Staff Report Number: CSOPS.24.018

125 Peel Street South Servicing
Public Information Centre Follow-up
Bill Abbotts

Louisa St

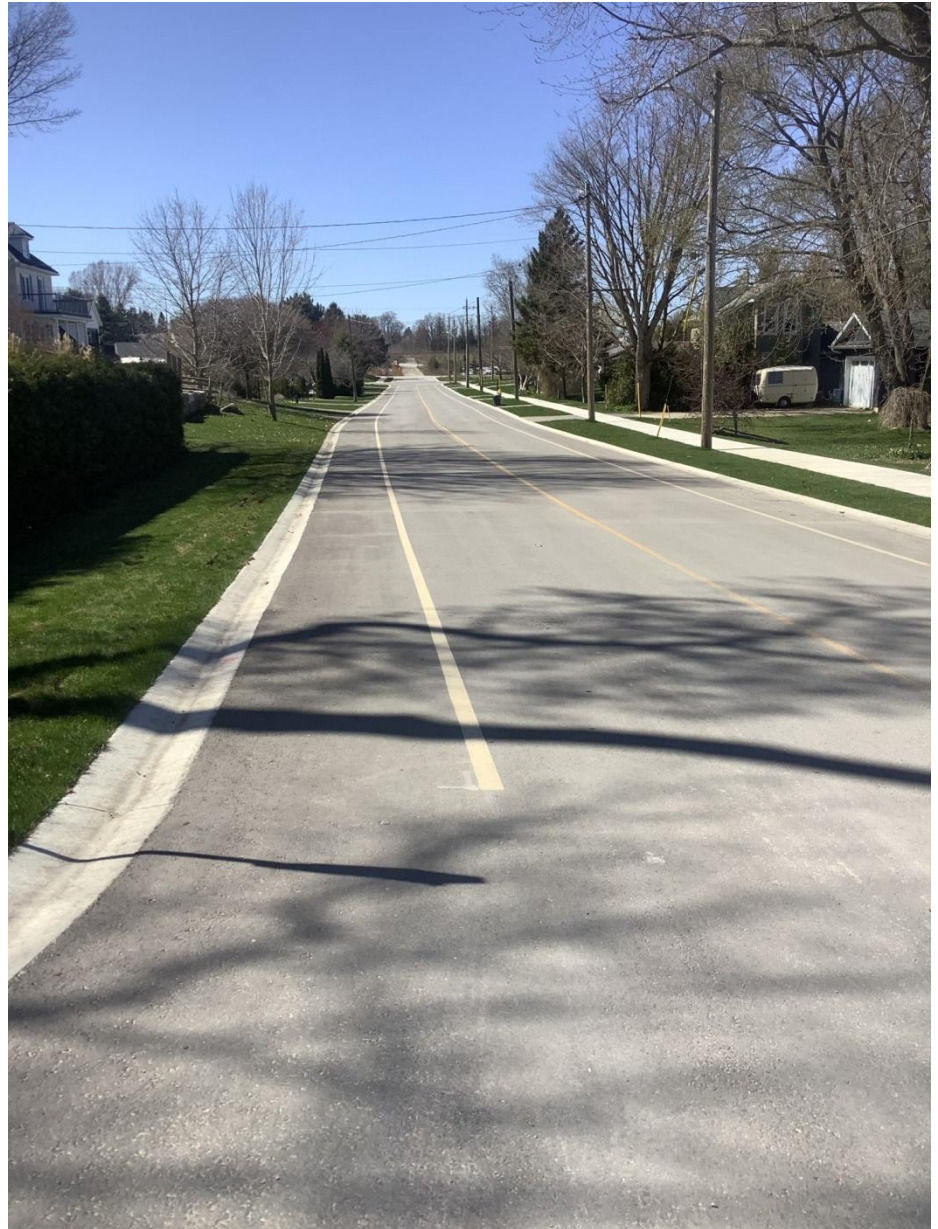
This is a photo of the recently reconstructed Louisa St west of Elma St S. After much discussion with a 2nd previous council and TBM staff of the time, all Thornbury West will be this profile. It is closer to our engineering standard than the MUT profile.

The vehicle lanes are 3 metres and the “fog lines” for active transportation are at 1.25 metres. Pavement width of 8.5 metres.

There is a 1.5 m sidewalk on one side.

The curbs are semi mountable for cyclists safety and cross street access for mobility devices, strollers, etc.

PEEL ST. SOUTH ALTERNATIVE NO. 2: FULL URBANIZATION

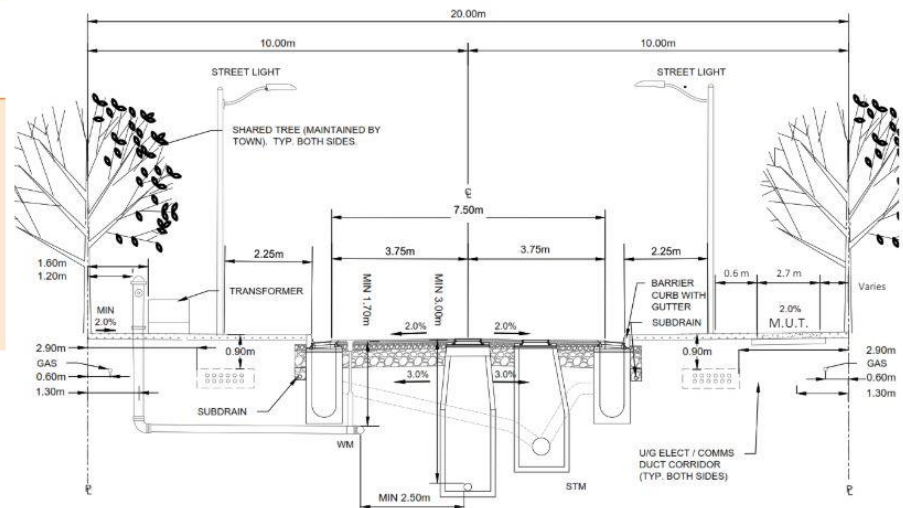
Regarding the report, I maintain the staff “aligns” assumptions and advantages / disadvantages in the report are severely flawed.

The Transportation Master Plan, of which I was a committee member, does not promote Multi Use Trails in urban settings. OTM Book 18 backs this up.

The proposed MUT on the Peel St N project is a dangerous mistake just waiting for accidents to happen if it is constructed as proposed.

My ask: Do not approve motion as presented in terms of Peel St profile Alternative 2. Direct staff to pursue a profile similar to the Louisa St photo and the rest of Thornbury West, High Bluff Lane, Timber Lane etc, including painted lines and semi mountable curbs. This is a safer, slight modification of the current 8.5 metre Engineering Standard for 20 metre urban streets.

Profile comparison

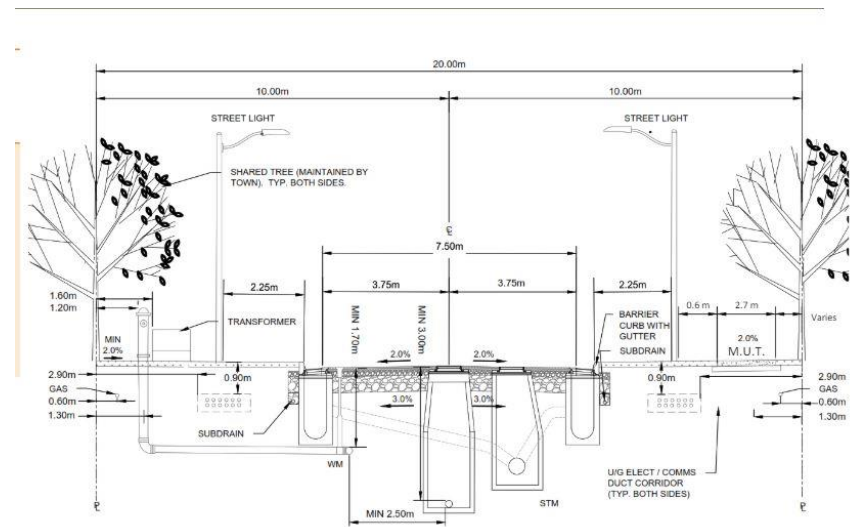
Louisa travel width requirements 10 metres – 3 metre vehicle, 1.25 metre paved shoulder, semi mountable curbs, 1.5 metre sidewalk = 10 metres.

By moving the centre line slightly to the east on Peel Street S more tree retention may be possible.

Proposed Peel St travel width requirements 10.2 metres – 3.75 metre vehicle, barrier curbs, 2.7 metre MUT = 10.2 metres. 0.2 metres more than Louisa profile. Slightly less room for tree retention

The standard I am requesting is to use is the 8.5 metre pavement with 3 painted lines to give 3 metre vehicle lanes and 1.25 fog lines (active transportation shoulders) with a 1.5 metre sidewalk on one side. Painted lines do not narrow the pavement width when required for larger vehicles but the painted 3 metre vehicle lane promotes traffic calming.

Engineering Standards

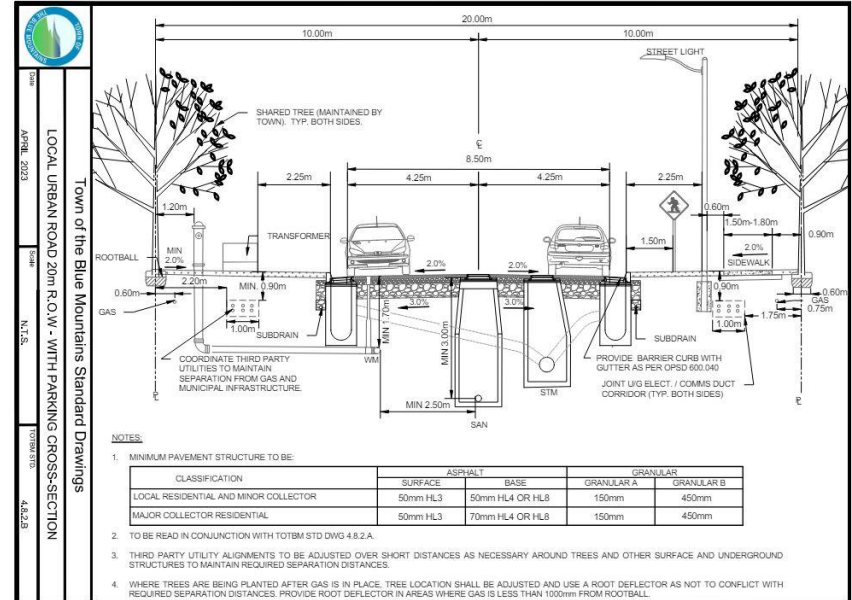
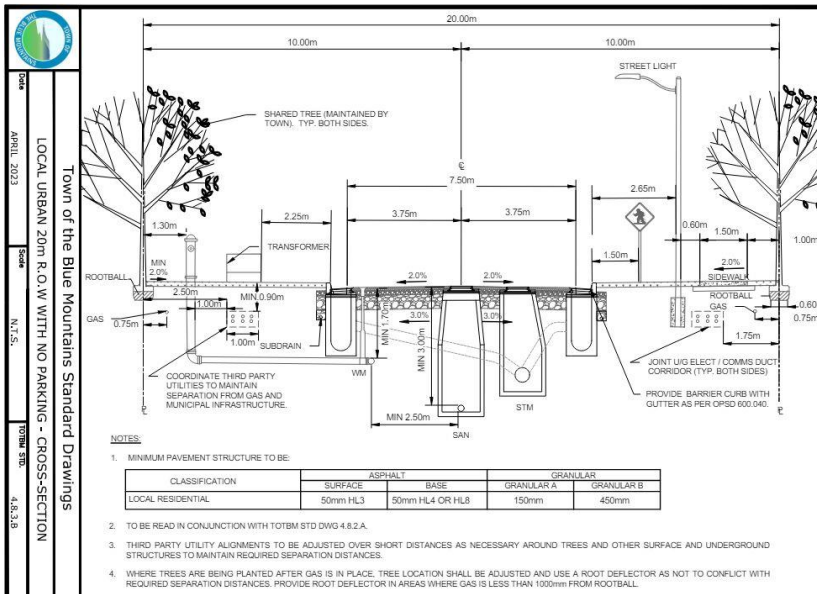
Both I could find have a 1.5 metre sidewalk on 1 side

No parking - pavement width of 7.5 metres – works with sharrows for cyclists.

With parking - pavement width of 8.5 metres – perfect for 3 metre vehicle lanes and 1.25 paved shoulders!
